<b>Clark Consulting Engineers</b> 19 Ryan Road Edgewood, New Mexico 87015 Tele: (505) 281-2444 Fax: (505) 281-2444	
DATE	REVISION
LOT 9-A, BLOCK 2, NORTH FOUR HILLS SANDOVAL COUNTY, NEW MEXICO TUAN VAN HUYNH RESIDENCE	
<b>GRADING &amp; DRAINAGE PLAN</b>	
DESIGNED BY: PWC	DRAWN BY: CCE
CHECKED BY: PWC	DATE: 4/6/12
JOB #: TUAN_RES	FILE #: G/D

<b>Clark Consulting Engineers</b> 19 Ryan Road Edgewood, New Mexico 87015 Tele: (505) 281-2444 Fax: (505) 281-2444	
DATE: 8-24-12	REVISION: REVISED PER RE-DESIGN WITH WALK-OUT BSMT
LOT 9-A, BLOCK 2, NORTH FOUR HILLS ALBUQUERQUE, NEW MEXICO <b>TUAN VAN HUYNH RESIDENCE</b> <b>GRADING &amp; DRAINAGE PLAN</b>	
DESIGNED BY: PWC	DRAWN BY: CCE
CHECKED BY: PWC	DATE: 4/8/12
JOB #: TUAN_RES	FILE #: G/D
1 OF 1

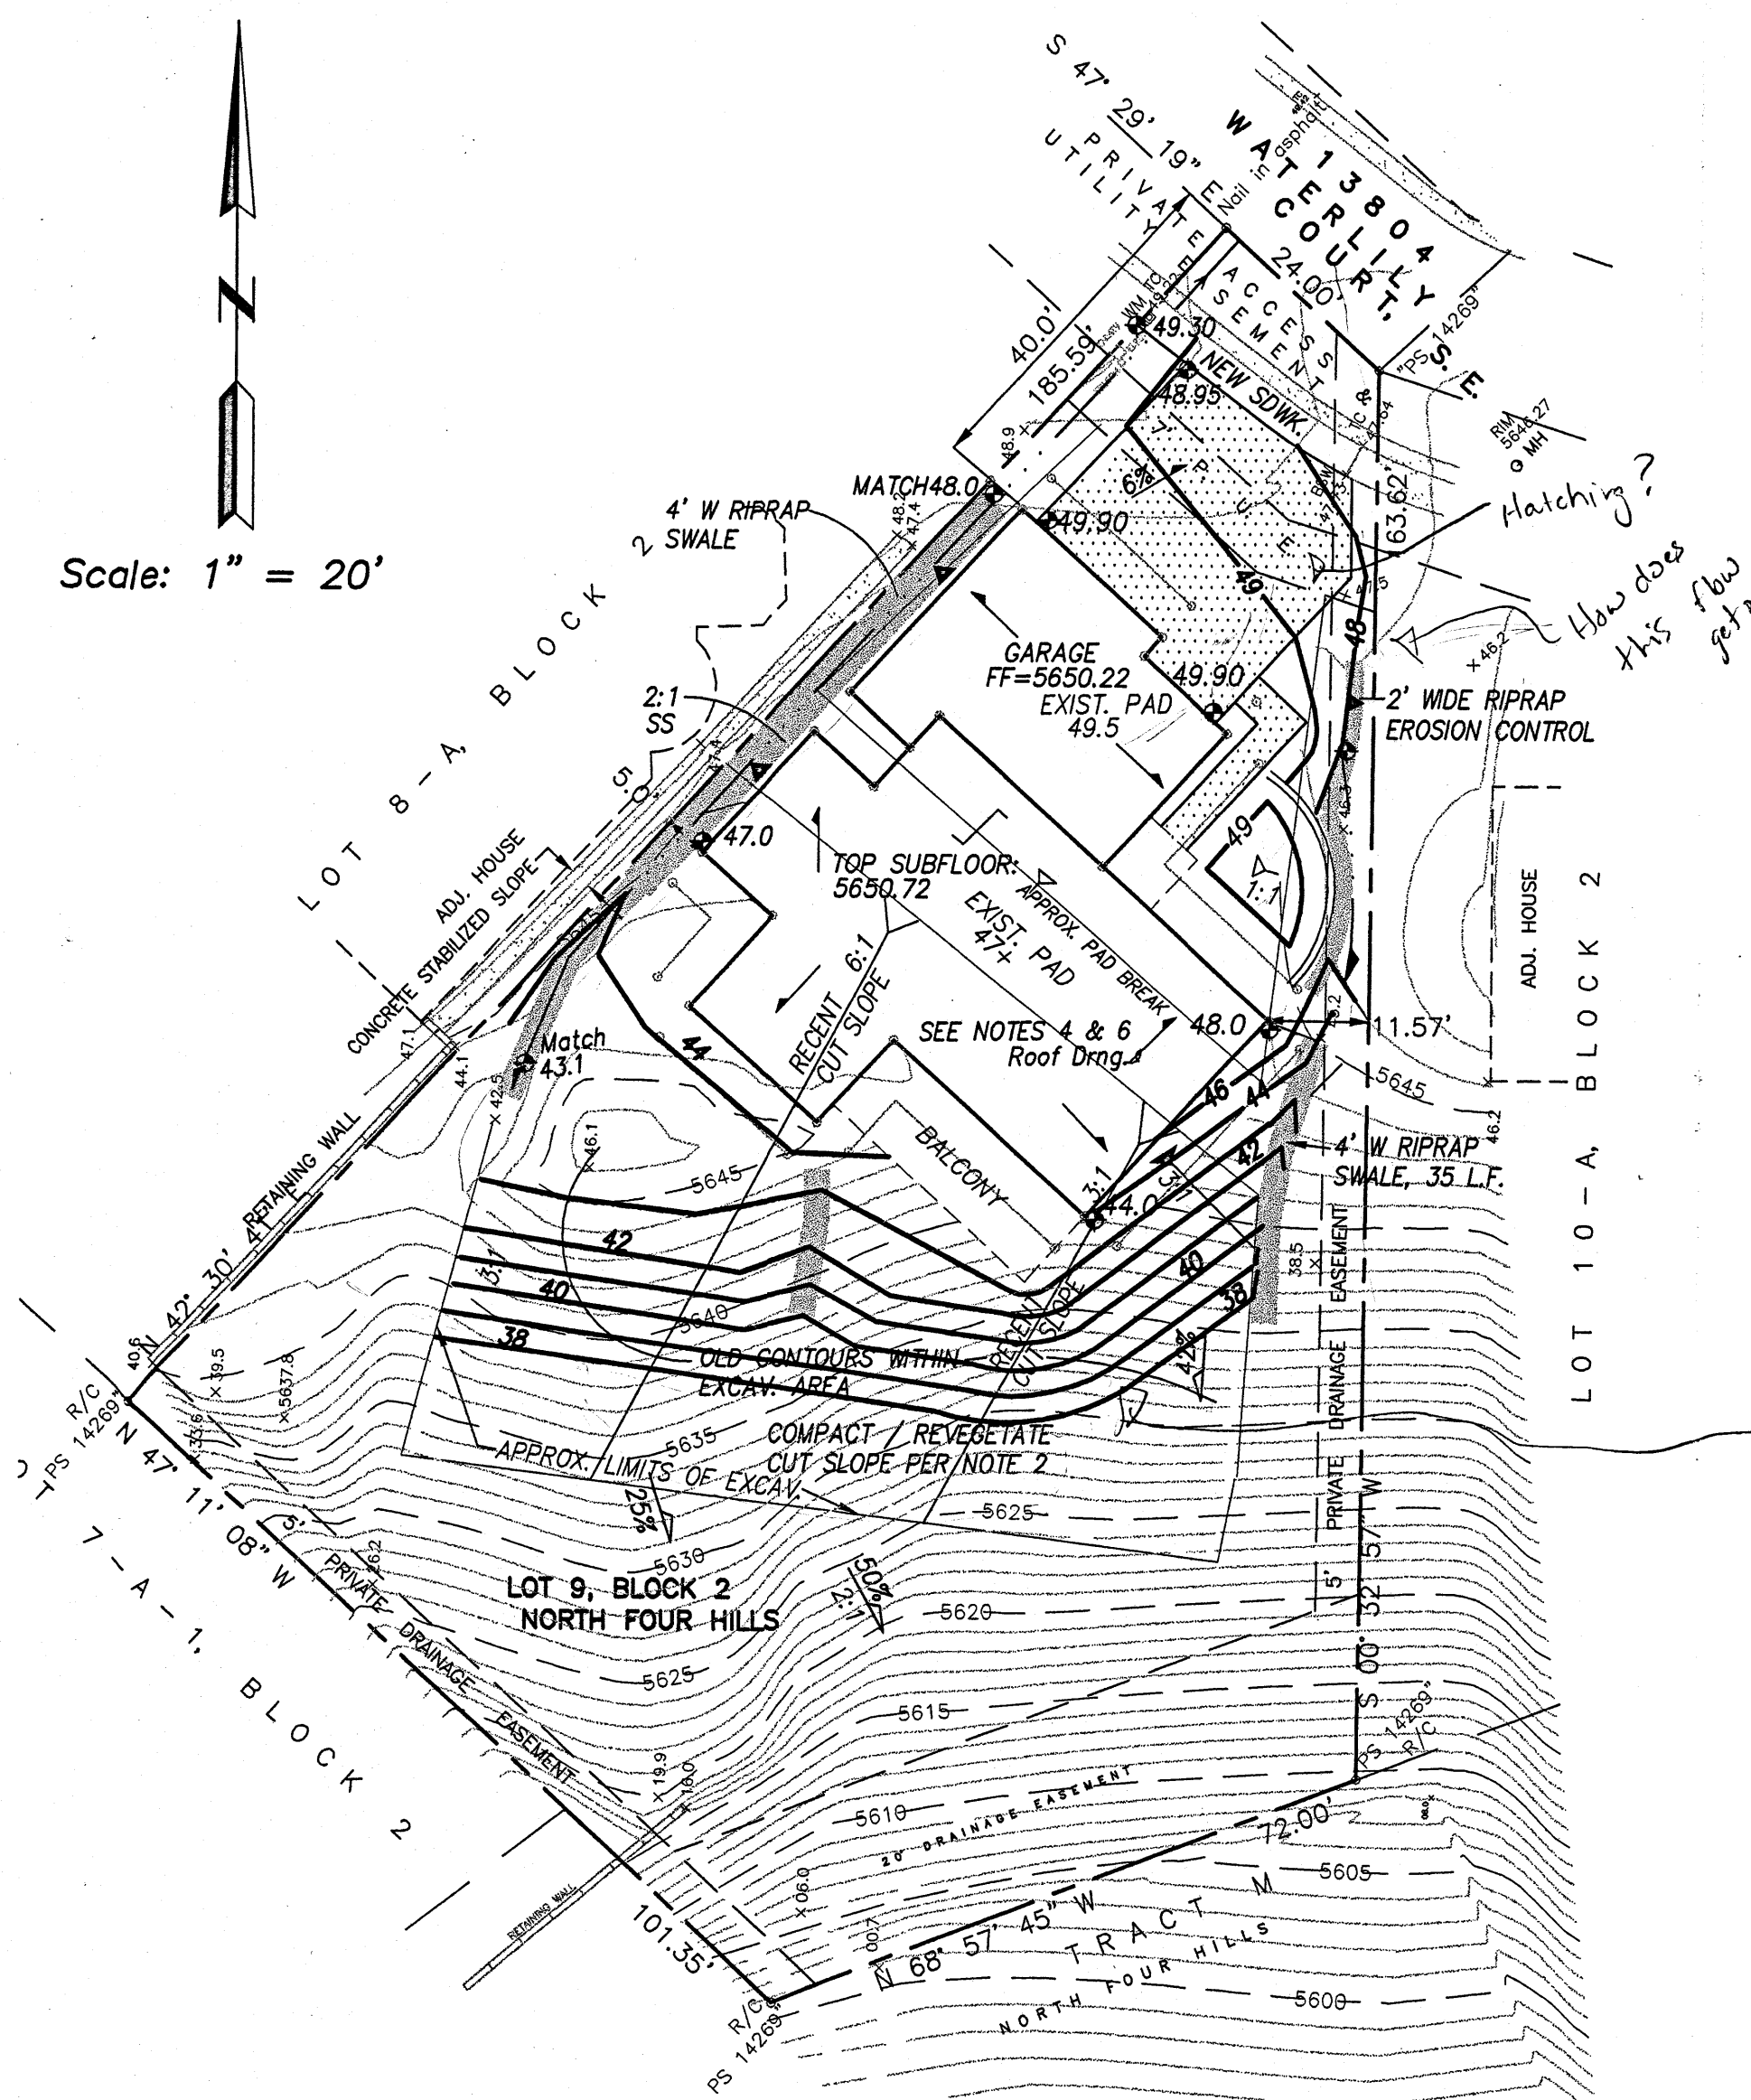
Proposed/Existing contours?
